Re: Proposed Sampling Request
Jones D Tank Battery
API No. 30-015-00192
GPS: Latitude 32.7506142 Longitude -104.3300247
UL "H", Sec. 13, T18S, R26E
Eddy County, NM
NMOCD Ref. No. NMLB1401534243, nRM2008547914

Jones D Tank Battery
API# 30-015-00192
Eddy County, NM
Sampling Map

The Jones D Sampling Plan is approved with the following conditions:

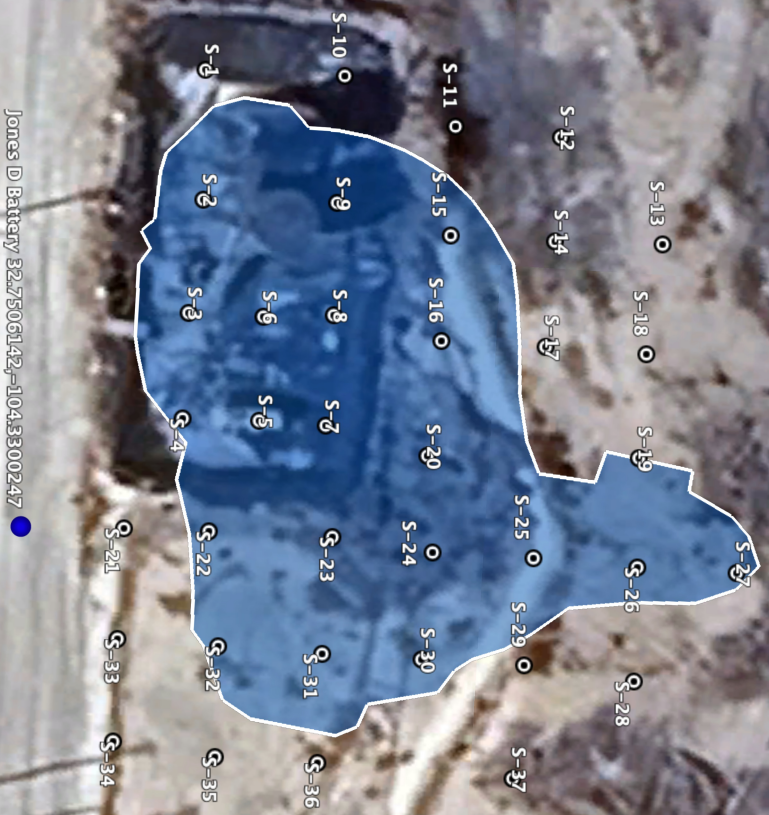
- The site must be delineated to the most stringent closure criteria found on Table I of 19.15.29 NMAC. If delineation is not achieved at the depths or the proposed locations found on the Sampling Map, deeper samples than what is proposed and additional horizontal delineation samples must be collected until full horizontal and vertical delineation is achieved.

- Be advised that OCD does not have any record of an 18 feet deep excavation or delineation that took place in 2020. Additional delineation past the depth of 18 feet may still be warranted if sample results show contamination has not been delineated deeper than 18 feet.
